I am here to submit my objection on Harbourside Shopping Centre Redevelopment. The purpose of redevelopment is to improve and revitalize the existing, to design a better place and then try to achieve the best result, instead of creating the following problems and minimize the impact to all parties.

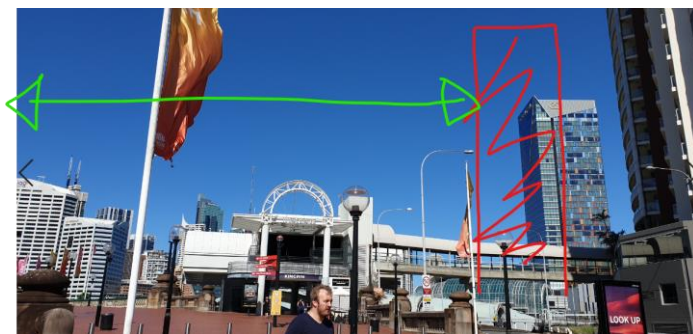
This photo is taken at the corridor between Ibis and Novotel. It was one of the main walkway to work for the community lives in Pymont .

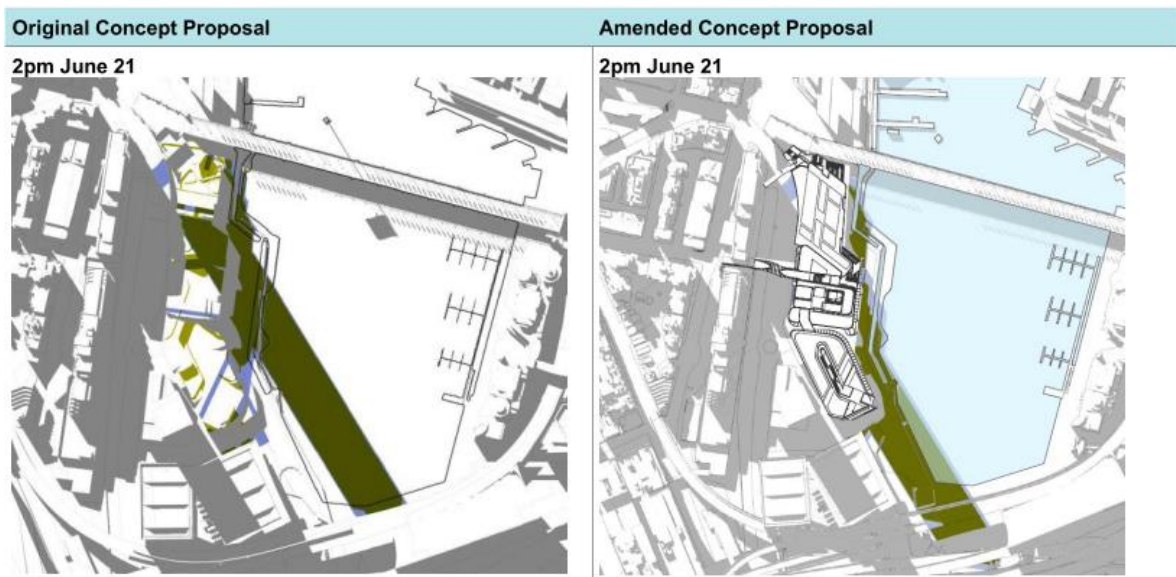
Photo is taken at the Pymont Bridge Rd, the main exit of Pymont. The open space is getting narrow as indicated.

↑ This is the main entrance of Darling Harbour. It is already not too welcoming as you can see the highway cutting across the area, causing overshadowing and noise. With the addition of the new tower, the width of the entrance will be narrower visually as shown above. The overshadowing during winter as marked in the report in a lighter green colour on the amended concept proposal (see below) made it look better & less impact? A misleading marketing strategy.

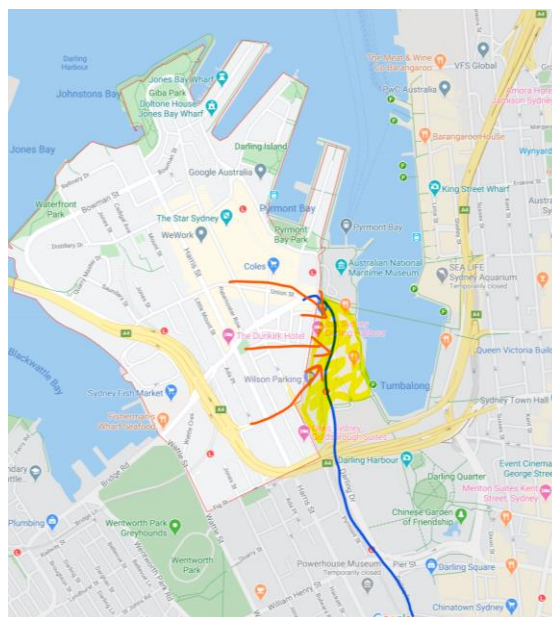
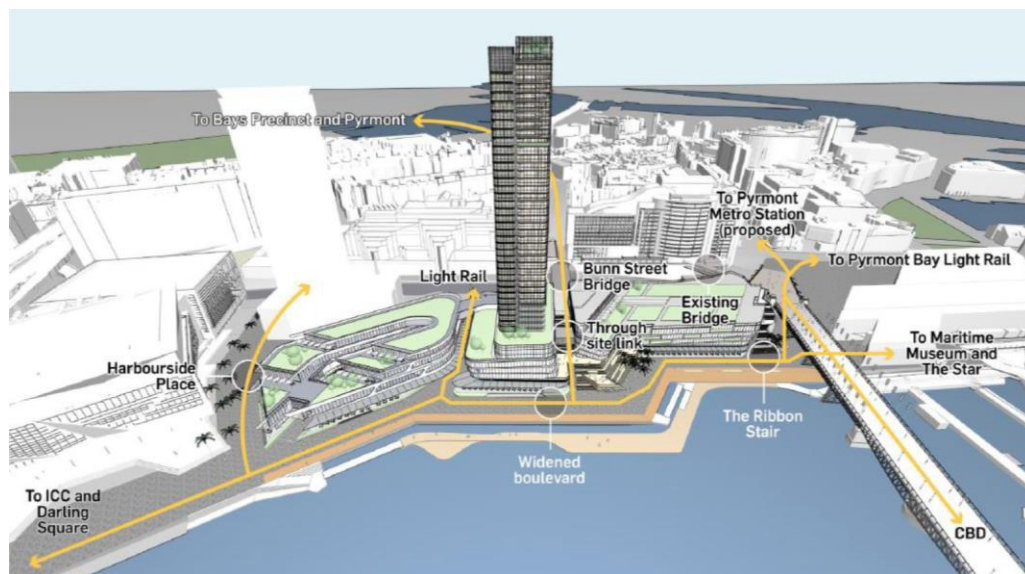
There is a disconnection between Pymont and Darling Harbour, caused by the Darling Drive, the light rail with fences and the significant level difference between the harbor side and street level of Pymont (e.g. Murray Street, Harris Street and Pymont Bridge Rd). Like a knife cutting across, isolating the entire Pymont Precinct. This is significantly causing inconvenience to the community and the visitors from public carpark behind the shopping mall to visit the harbor.

Building foot bridges to create access to harbor does not mean connecting the precincts or merging with the surrounding. Such redevelopment is a great and only opportunity to bring and introduce the Pymont precinct into the waterfront. Not simply and physically connecting them, but connecting them by the experience of the journey. The following is my suggestions:

1. The northern end of the redevelopment has already been connecting well with the Pymont Bridge and Pymont Bridge Road. The staircase can be more generous and open to allow pedestrian to look at the harbor while walking down. Currently it looks like a little alley stair coming down in-between
2. Regarding to the Roof Top Garden, it is a great proposal to bring some green in to the waterfront and in some way it connects the Darling Quarter and the Pymont Bay Park together. Although there are noise, safety or other concern, it will be good to allow people, especially community of Pymont, to walk from Pymont Bridge Rd or Casino to the Roof Top and gradually into the mall or directly to the waterfront, like
 - a transition area from suburb to waterfront
